In The Drawings:

REMARKS**Introductory Comments:**

Annotation Marked-up Drawings Application No. 10/707,501

**FIG. 1**

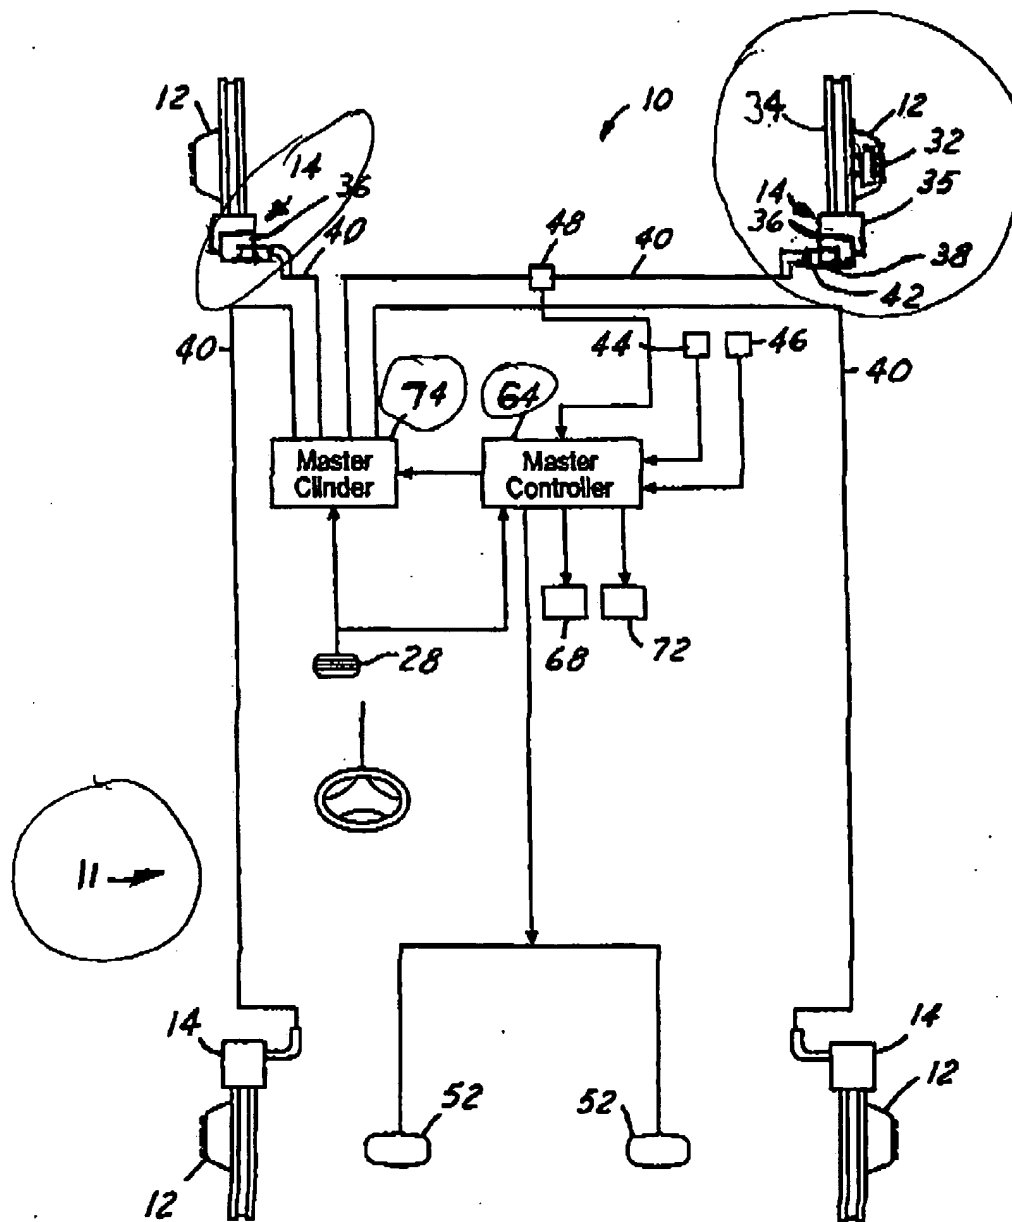
Regarding the drawing objections discussed in paragraph 1 of the Office Action, Applicants have amended the drawings in accordance with the Examiner's suggestions. Further, Applicants have added Figures 1A, 1B, and 1C to illustrate further the components discussed in paragraph 1 in accordance with the description provided in paragraphs [0037] and [0045]. No new matter has been added. Applicants therefore submit one Replacement Sheet containing Figure 1 and one New Sheet of drawings containing Figures 1, 1A, 1B, and 1C.

Regarding the drawing objections discussed in paragraph 3 of the Office Action, the Applicants have amended the drawings in accordance with the Examiner's suggestions.

The Specification is objected to for various informalities. The Applicants respond to the aforementioned objections by amending the Detailed Description of the Preferred Embodiment in accordance with the Examiner's suggestions with the following exception: rather than change all references to "cylinder 74" and "controller 46", Applicants have instead amended Figure 1 such that the specification items (cylinder and controller) are now properly identified in the drawings.

Please substitute the one sheet of drawings submitted herewith containing Figure 1 in place of the originally filed drawing sheet containing the same figure. Also, please add one sheet of drawings submitted herewith containing new Figures 1A, 1B, and 1C.
